# PRELIMINARY DRAINAGE PLAN

## CREEKSIDE AT LORSON RANCH FILING NO. 1

**AUGUST, 2018**

**PUDSP-18-005**

SHEET NUMBER  
**2**

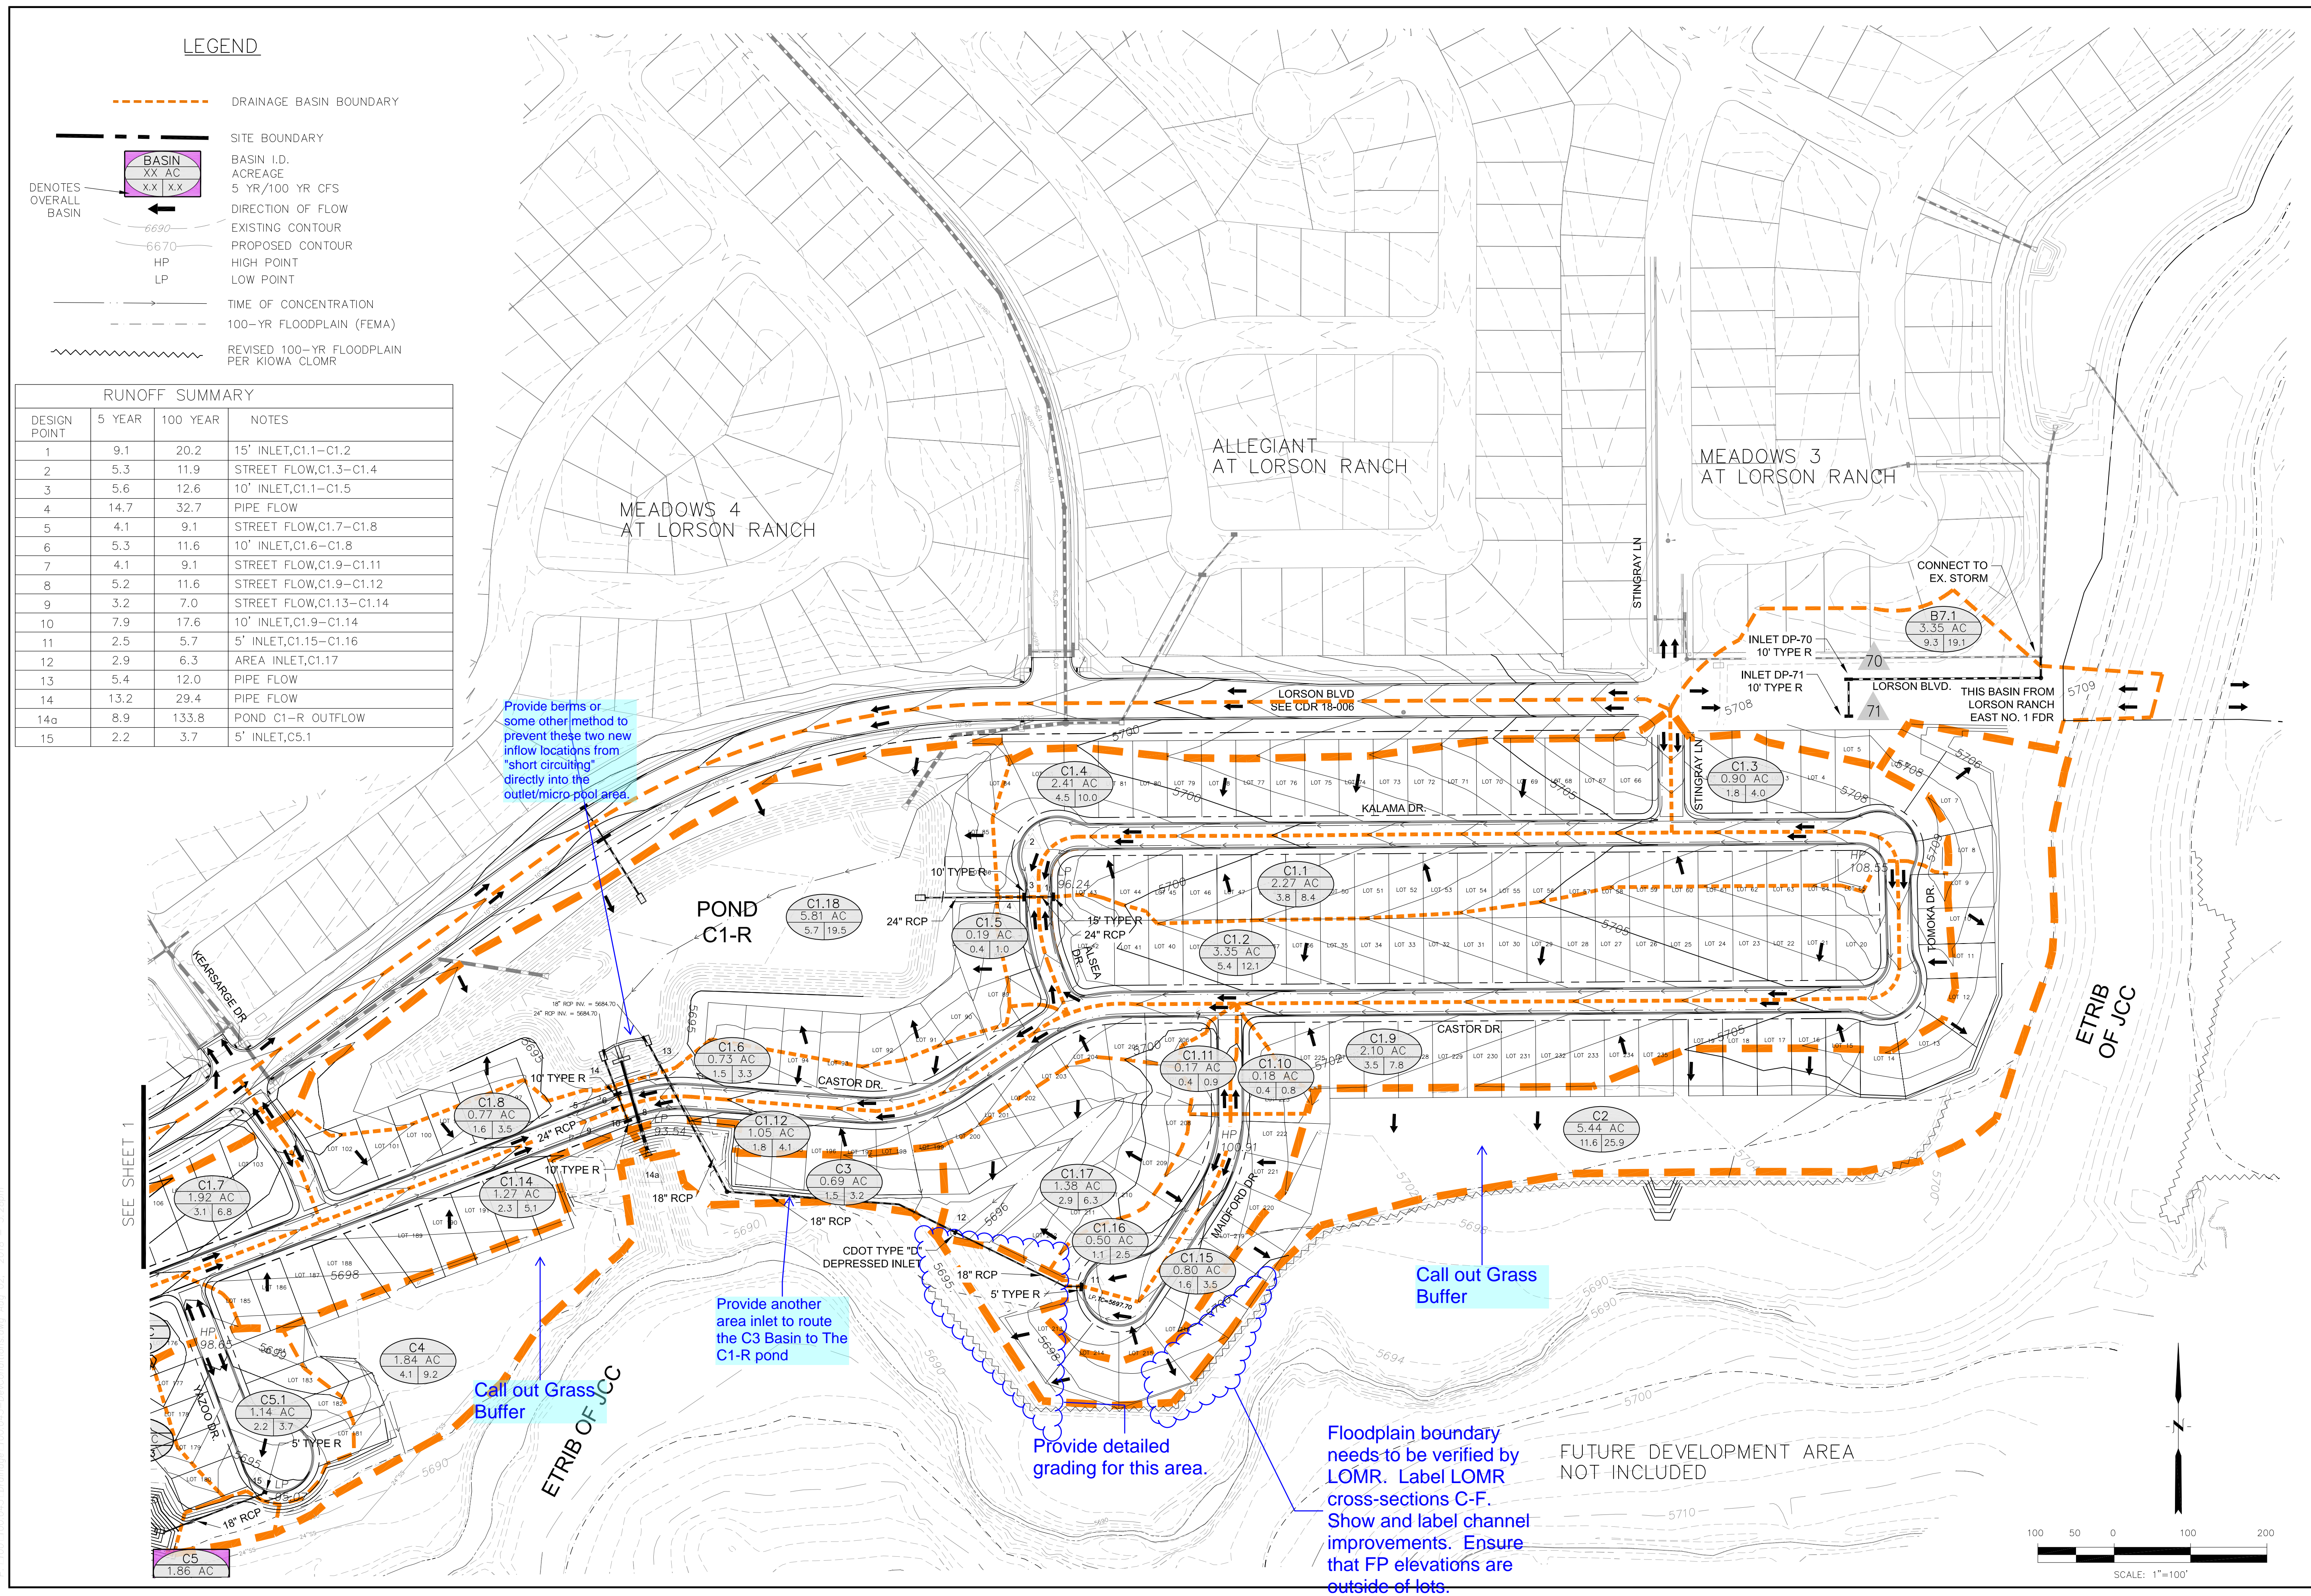
Provide berms or some other method to prevent these two new inflow locations from "short circuiting" directly into the outlet/micro pool area.

Provide another area inlet to route the C3 Basin to the C1-R pond

Call out Grass Buffer

Provide detailed grading for this area.

Floodplain boundary needs to be verified by LOMR. Label LOMR cross-sections C-F. Show and label channel improvements. Ensure that FP elevations are outside of lots.
